MEMORANDUM

To: Design Review Board
From: Jon Regala, Senior Planner
Date: September 14, 2015
File No.: DRV15-01765
Subject: VILLAGE AT TOTEM LAKE (AKA TOTEM LAKE MALL)
DESIGN RESPONSE CONFERENCE

Site Pedestrian Access Plan

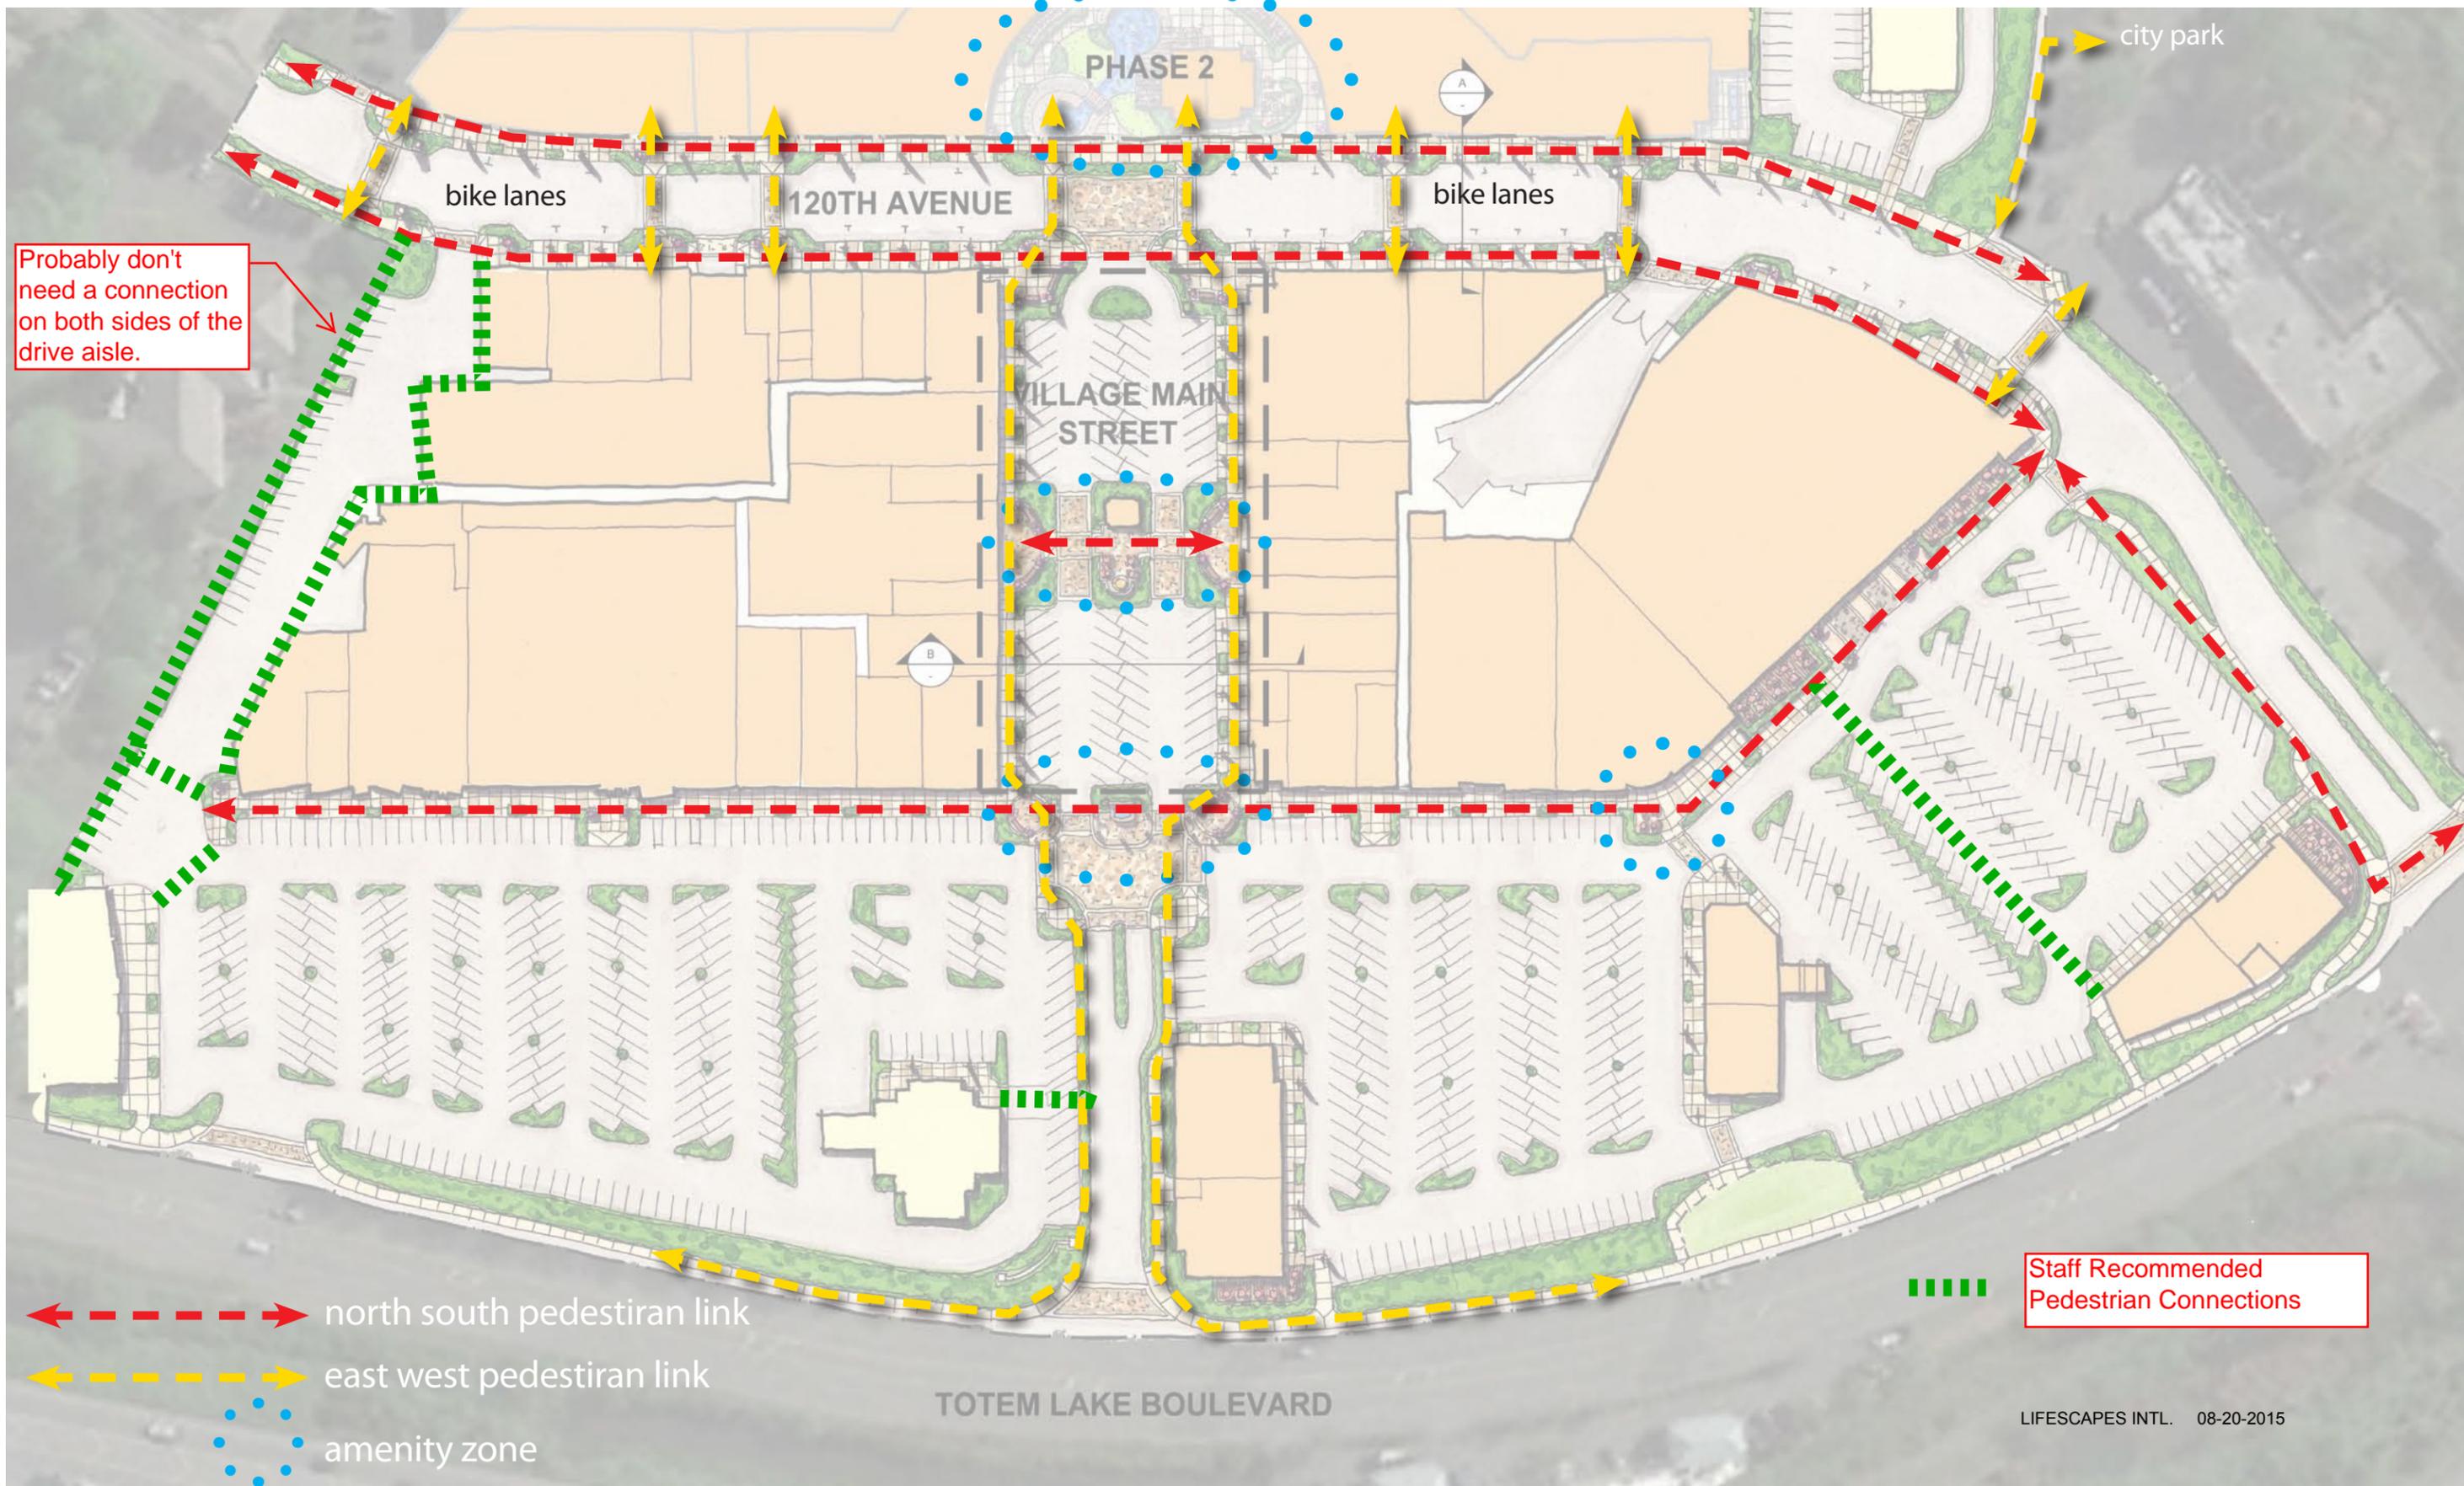
2. A condition of the Amended CMP is that loading and service areas shall be located away from 120th Avenue NE and pedestrian areas. The proposal shows the main loading area for Building A located behind Whole Foods with access to 120th Avenue NE. Are there design changes needed to mitigate visual impacts and impacts to the pedestrian environment?
3. Are additional pedestrian connections within the site and to adjoining properties to the north needed? Does the DRB agree with the pedestrian connections recommended by staff (see Attachment 3, page 14 – green dashed lines)?
4. Does the DRB have other comments on the proposed Site Pedestrian Access Plan (see Attachment 3, page 14).

Probably don't need a connection on both sides of the drive aisle.
